Addendum No. 2 to IFB 26-50

To: All Parties on Record with the City of Somerville as Holding IFB 26-50
Somerville Police Station Parking Control Gates

Re: Changes to DCAMM Classifications for the General Contractor, Updated Technical Specifications and Drawings

Updated Drawings (C-1.0, C-2.0, E-311, and E-700):

DUCT BANK SECTION

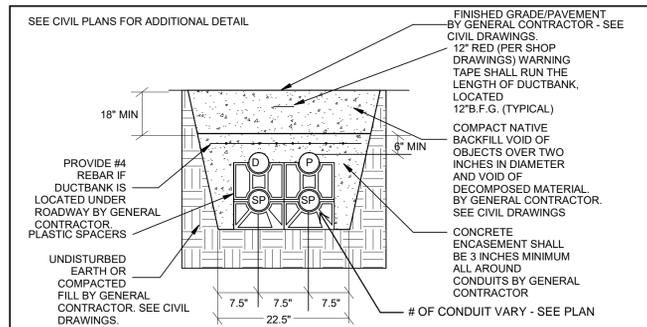
Revisions have been made to clarify the scope of work. The electrical duct bank detail has also been updated to reflect concrete encasement in lieu of direct burial of conduits.
